AGENDA  
 PEACH BOTTOM ATOMIC POWER STATION, UNITS 2 AND 3  
 LICENSE RENEWAL APPLICATION  
 MONDAY, OCTOBER 22, 2001

**PURPOSE:** To provide Exelon an opportunity to clarify the scoping and screening methodology, particularly as it relates to the use of system "realignment" to determine components within the scope of renewal. The NRC staff expects to understand how this process fulfills the requirements of §54.4 in sufficient detail to complete the review of the system scoping results and the methodology.

License Renewal Application  
Scoping and Screening  
Methodology meeting

October 22, 2001

Figure 2.1-1 - Scoping and Screening Process Overview

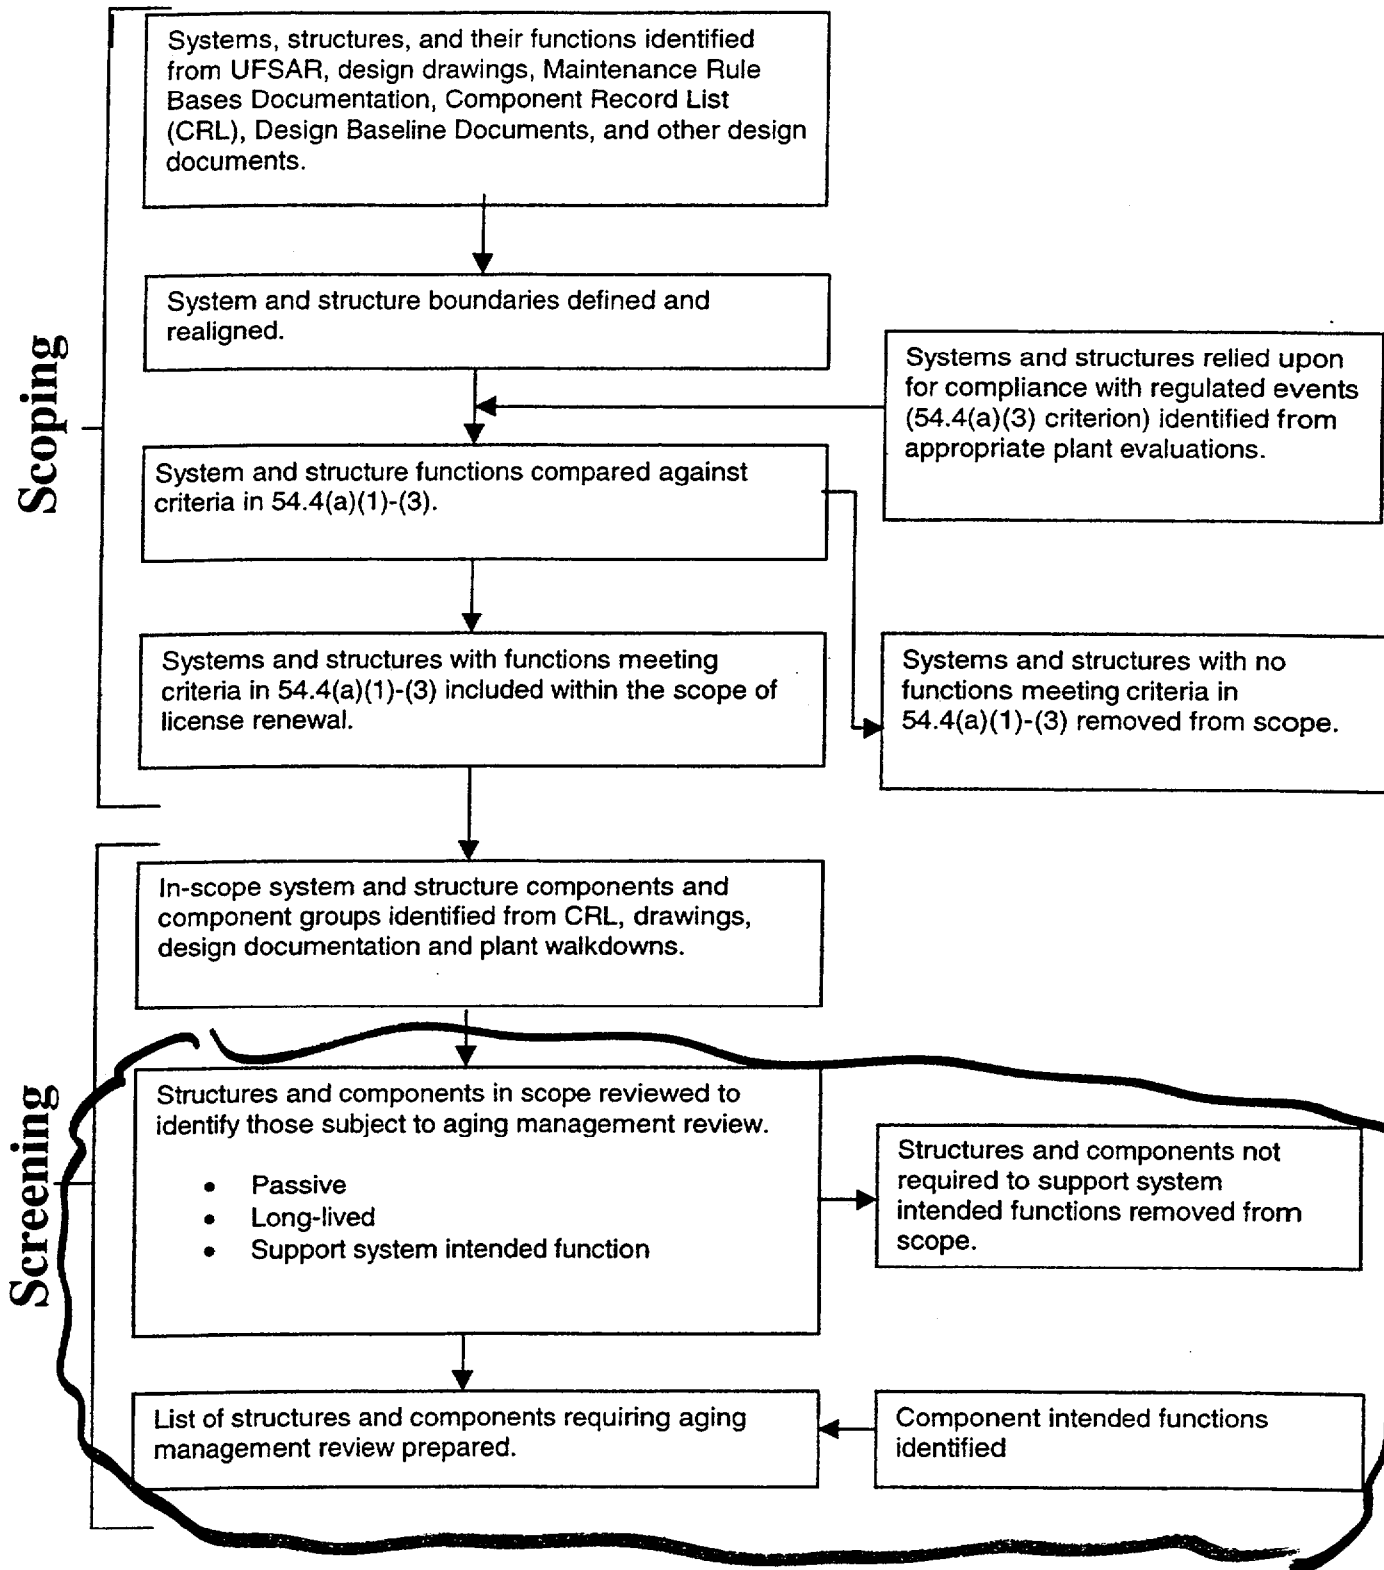
1	Introduction : Define the issues and expected outcome of the meeting.	NRC	9:00am
2	Clarify the scoping and screening process as shown in figure 2.1-1 of the PBLRA, as discussed at the meeting on 9/24/01, and explain how Exelon concluded that this process meets the requirements of 10 CFR 54.4 with respect to the following: <ul style="list-style-type: none"> <li>• System intended functions.</li> <li>• Explain the system realignment process and the rational for its use.</li> <li>• Determination of system/structure boundaries.</li> <li>• How the systems, structures and components reflected in the Peach Bottom current licensing basis [as defined by §54.3(a)] are captured in a consistent manner in the scoping process.</li> <li>• Explain the differences between the Component Record List and the UFSAR and how they are treated by the scoping process and reflected in the LRA.</li> </ul>	Exelon	9.15am

-Break-		10:45am
3	Discussion of NRC examples of apparent scoping inconsistencies and LRA clarity that could hamper the transparency of the review process: <ul style="list-style-type: none"> <li>• Reactor Water Cleanup (RWCU) System example is not in-scope (Fig 2.1-1 vs §54.4) but SCs of RWCU are in-scope per §54.21.</li> <li>• Given that system boundaries have been realigned for the PB LRA, how can the staff efficiently determine that all SCs are included in the Component Groups defined by the PBLRA?</li> </ul>	NRC	11:00am
	-Lunch-		12:00pm
4	Exelon to provide explanation for the specific examples in item 3 as to how the scoping and screening process was performed to ensure that SCs that need to be in scope of license renewal are captured in a consistent manner, in accordance with Part 54.	Exelon	1:00pm

- A comprehensive list of systems and structures to be evaluated for license renewal scoping was produced from the above documentation sources (LRA page 2-2, Section 2.1.2.1, first paragraph). These information sources are consistent with NUREG-1800 Standard Review Plan for License Renewal Table 2.1-1, and also Table 3.1-1 of NEI 95-10 revision 3, endorsed by Regulatory Guide 1.188:

- Component listings were downloaded from the CRL for each system.
- Component listings were used to mark-up P&ID drawings to establish in-scope system boundaries (LRA page 2-5).
- Some non-safety related systems at PBAPS include safety related components. For example, isolation valves in the makeup water fill connection to the safety related High Pressure Service Water (HPSW) system are safety related because they are part of the HPSW boundary. The makeup water connection is from the Water Treatment System, which is not safety related, but these individual isolation valves are safety related. Other examples are described on page 2-5 of the LRA, under the sub-heading of System Boundary Realignment.

- This is a general overview of the process of addressing the license renewal scoping criteria, which is described in detail in LRA pages 2-6 through 2-10.
- For systems, evaluation against criteria 54.4(a)(1) and (2) is based on Maintenance Rule program scoping documentation (LRA page 2-6 and 2-7).
- For structures, evaluation against criteria 54.4(a)(1) and (2) is based on review of UFSAR seismic classification (LRA pages 2-6 through 2-8).
- For systems and structures, evaluation against criteria 54.4(a)(3) is based on review of appropriate plant evaluations for the regulated events (page 2-9 and 2-10). License renewal position papers were prepared to identify specific systems credited for 10 CRF 50.48 (Fire Protection) and for 10 CFR 50.63 (Station Blackout).
- ATWS systems determined from CRL ATWS data field.

- Screening Methodology described in LRA Section 2.1.3, page 2-12 through 2-14.
- Final listing of in-scope components identified from previously downloaded component listings.
- Components entered into a License Renewal Database.
- Additional components not included in the CRL were identified and added to the database.

- Screening Methodology described in LRA Section 2.1.3, page 2-12 through 2-14.
- Component active versus passive determinations made in accordance with 10 CFR 54.21(a)(1)(i) and the guidance of NEI 95-10.
- Long-lived components identified in accordance with 10 CFR 54.21(a)(1)(ii) and the guidance of NEI 95-10.
- During this detailed component level review, any additional components identified that are not required to support a system intended function are removed from the scope of license renewal. Component listings (the license renewal database) and boundary drawings were updated as required.
- Intended functions identified for the structures and components requiring aging management review.
